ADDENDUM NUMBER 2

Re: North Brunswick High School HVAC
South Brunswick High School HVAC
West Brunswick High School HVAC
Brunswick County Schools
Proj. Number: PC21P0006

MDI Proj. No.: 213763

HVAC RENOVATION FLOOR PLAN - AREA 'I'
SCALE: 1/16" = 1'-0"

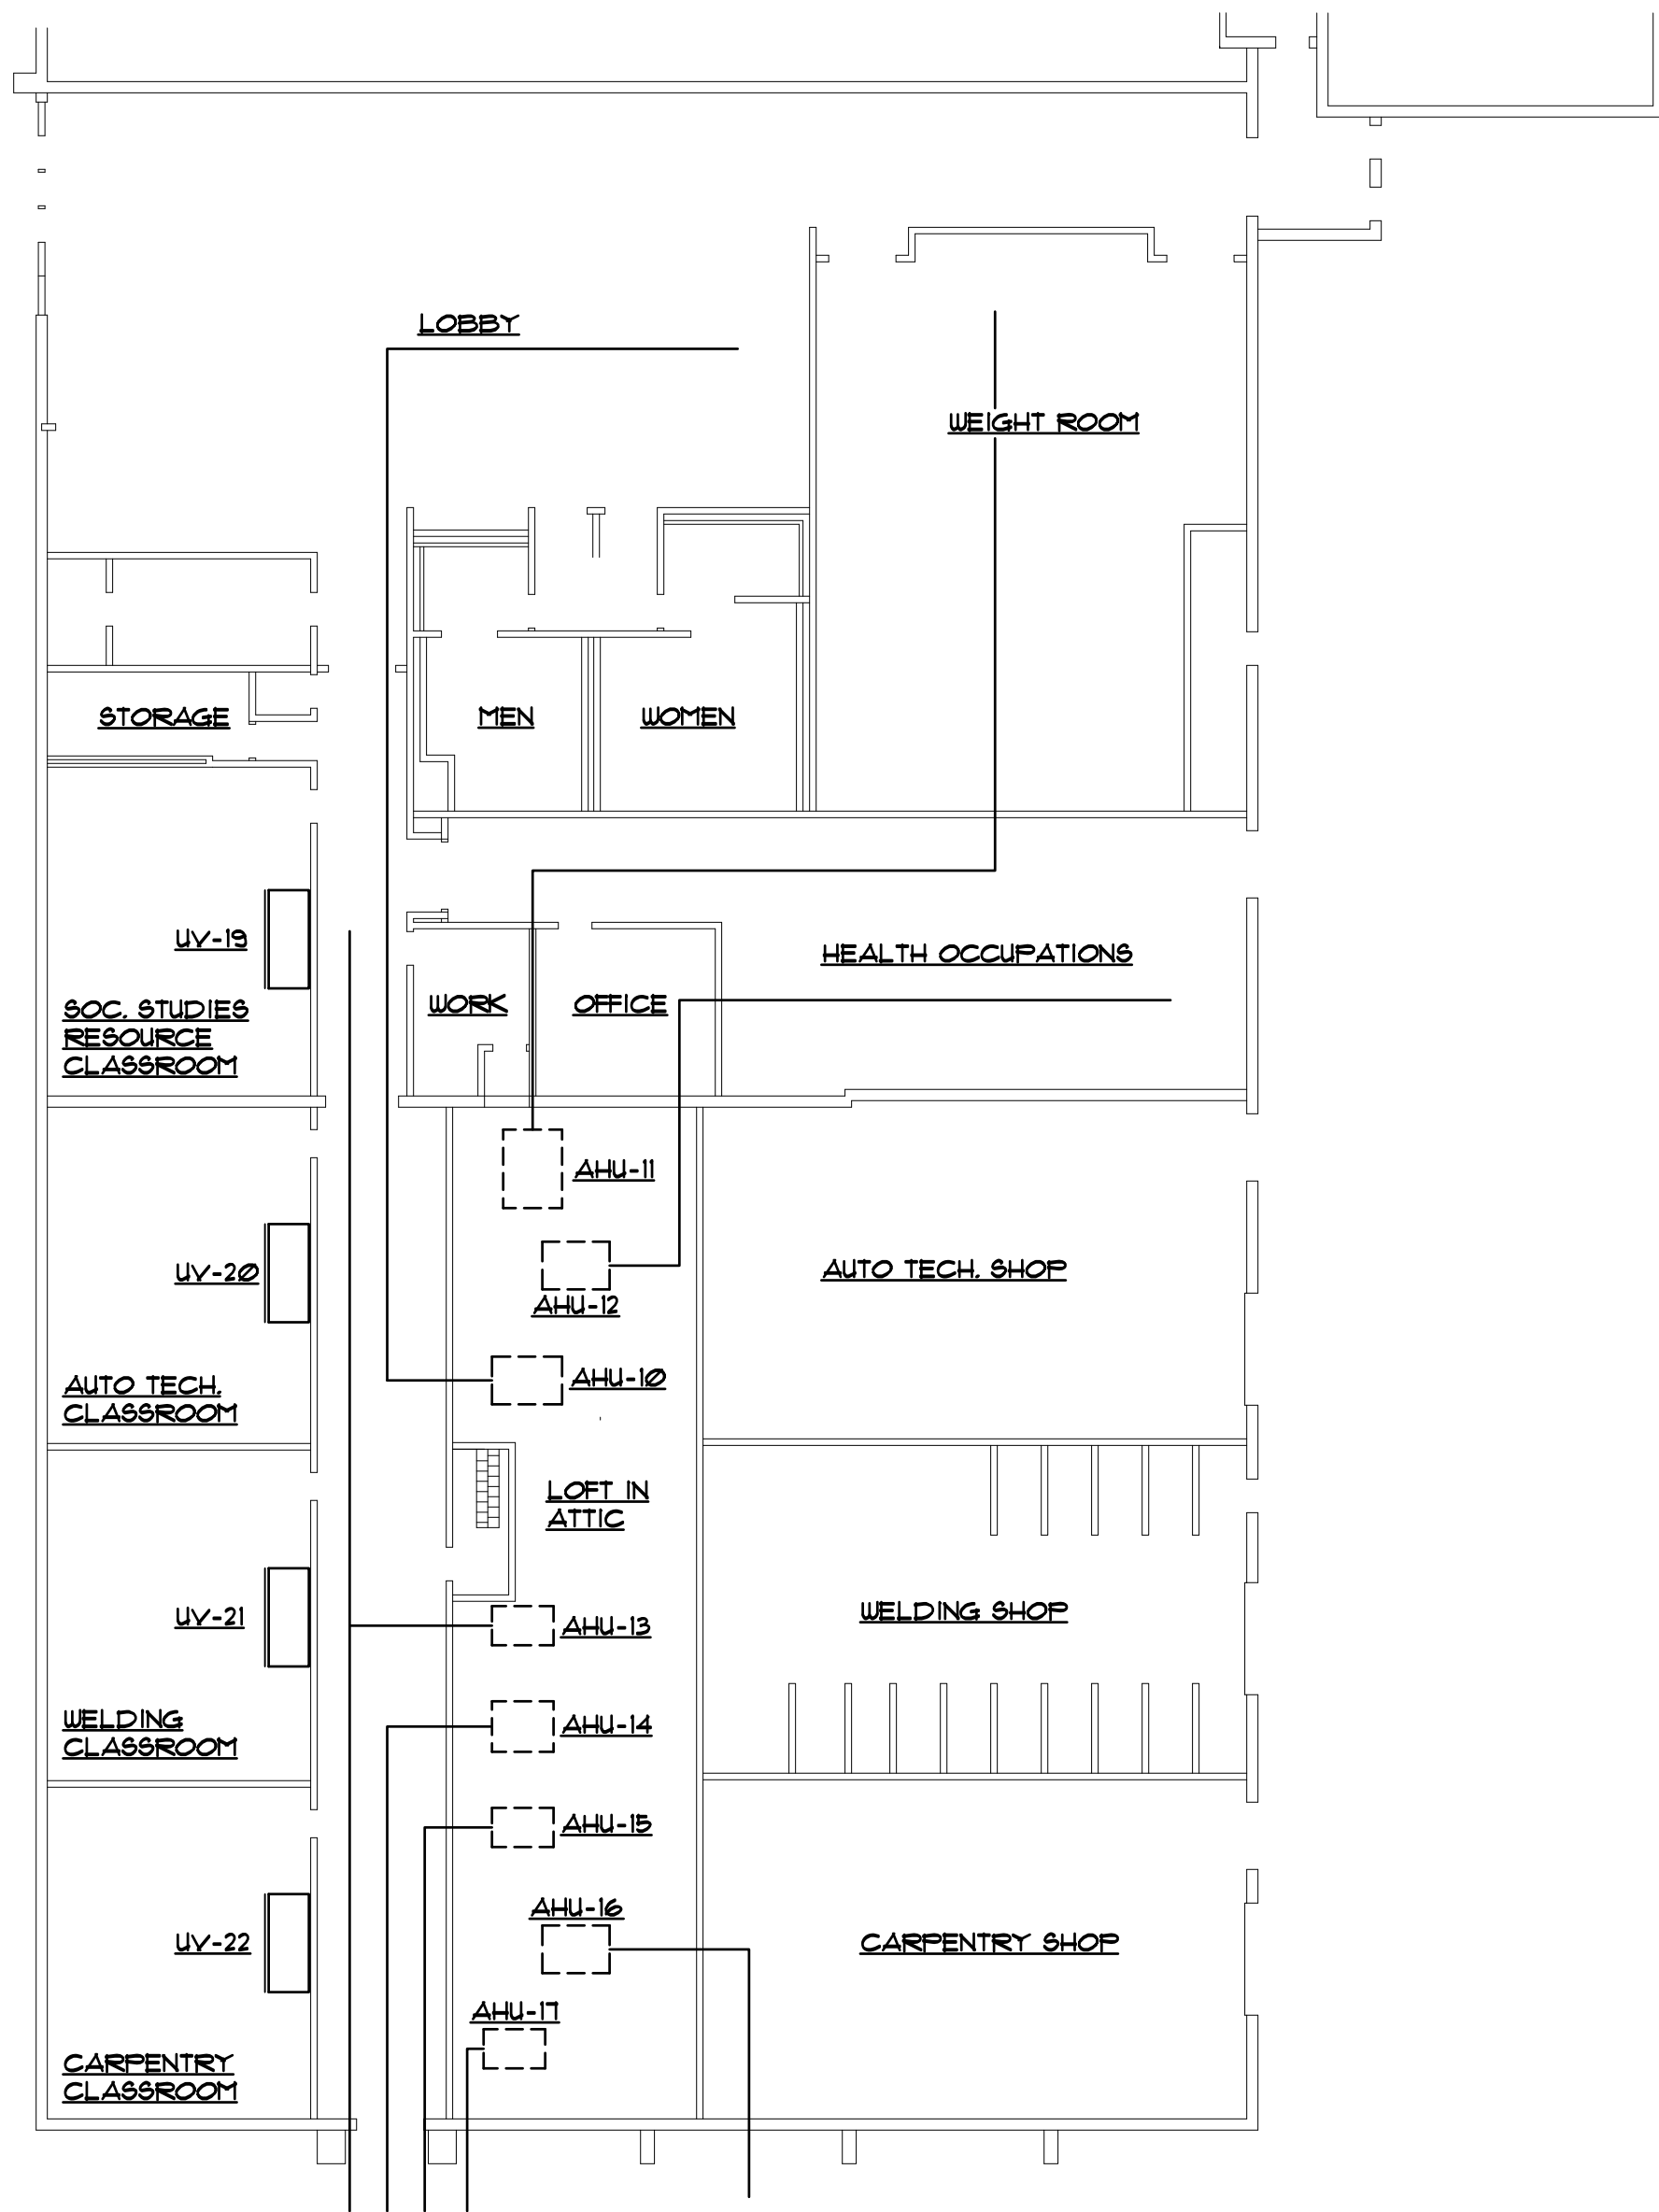
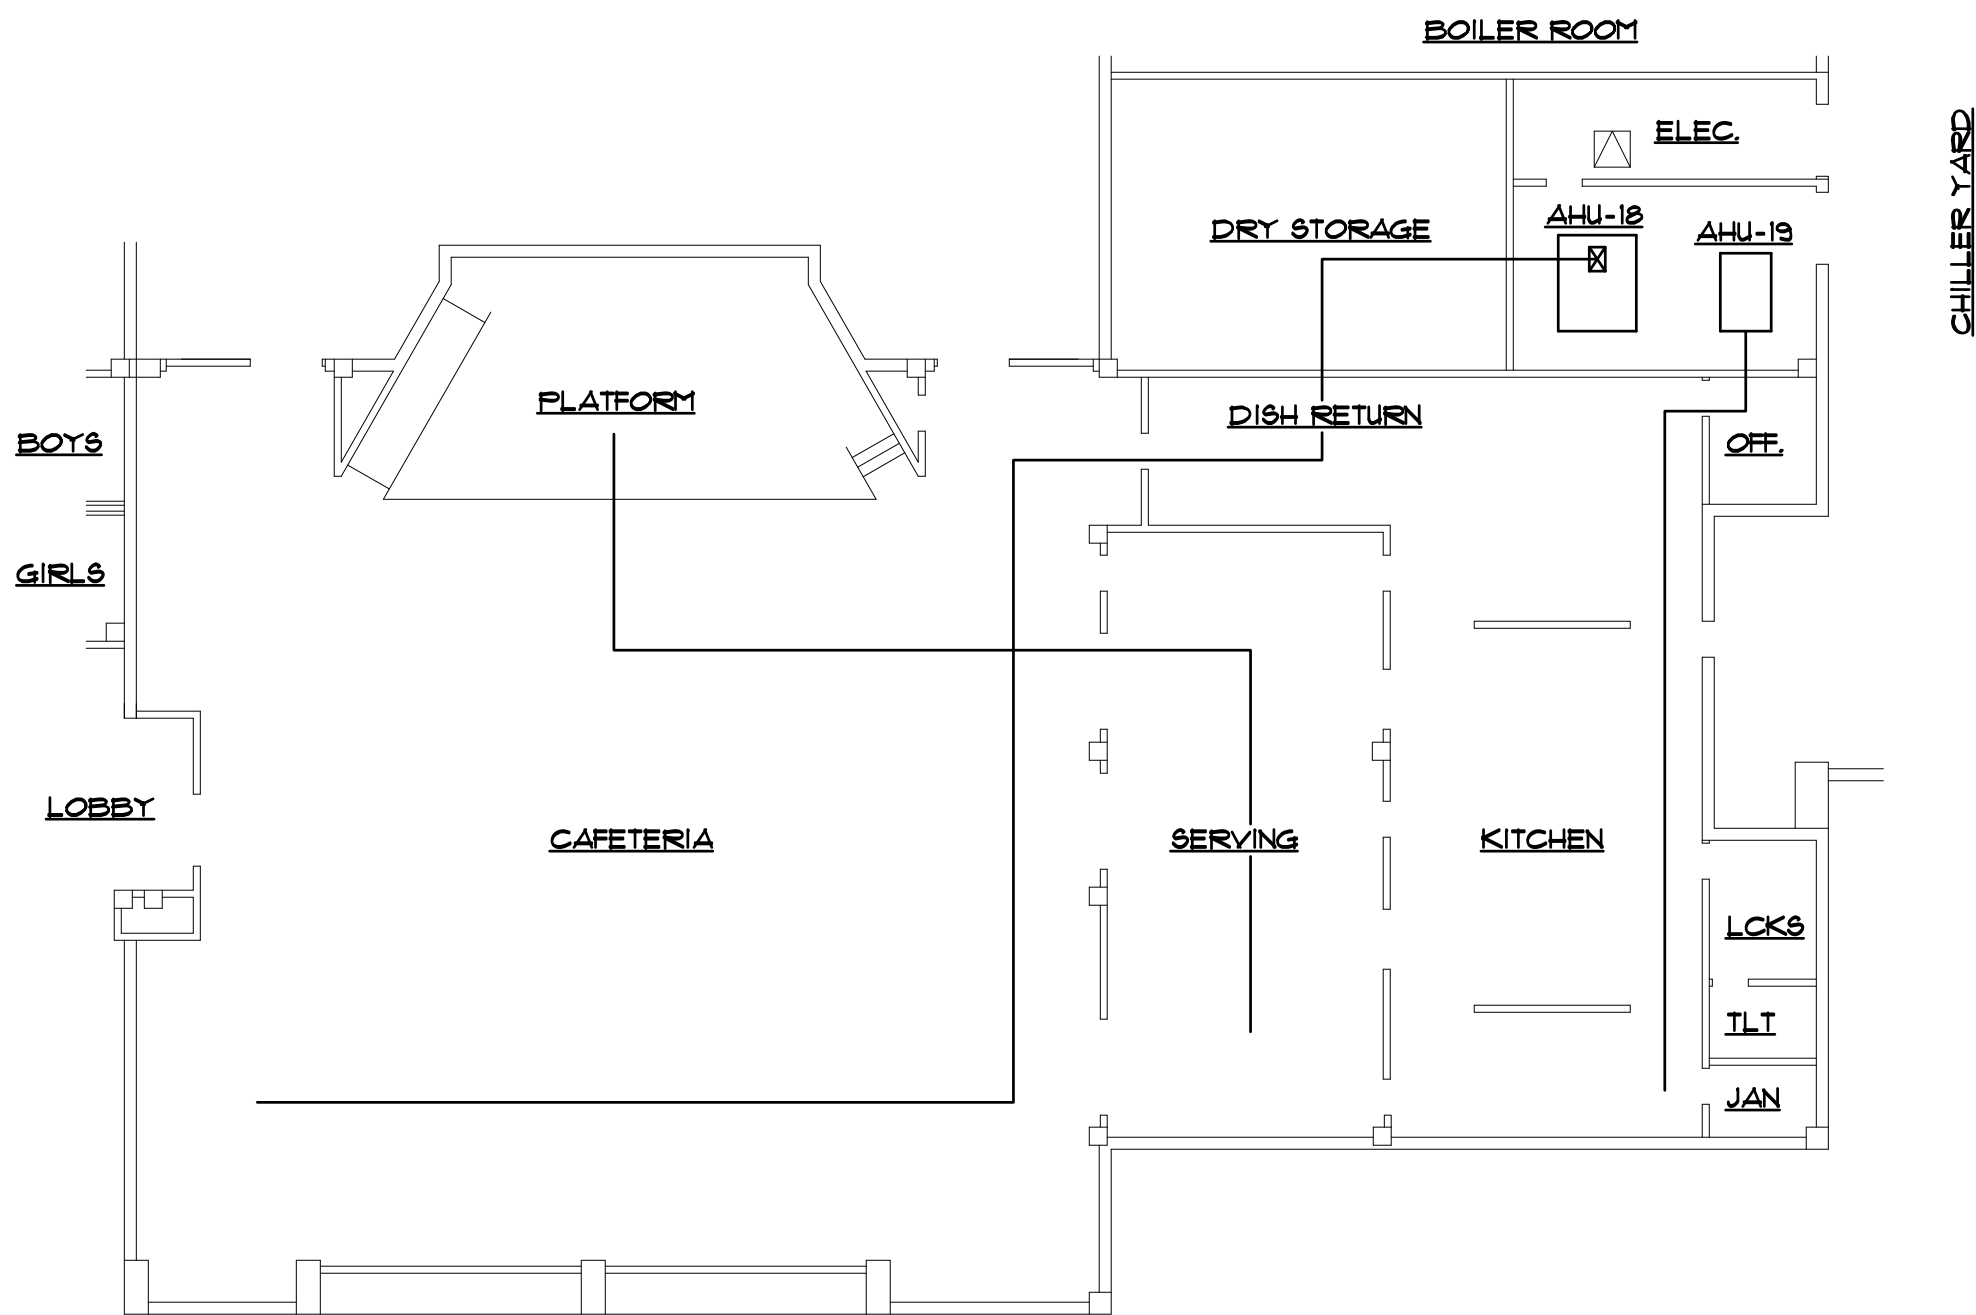
7. Refer to West Brunswick High School drawing M104A, areas "C", "D", "E", "G" and "I". Remove existing control valves complete, and replace with new control valves furnished by automatic temperature controls company as noted on the Control Valve Replacement Schedule on M001A.
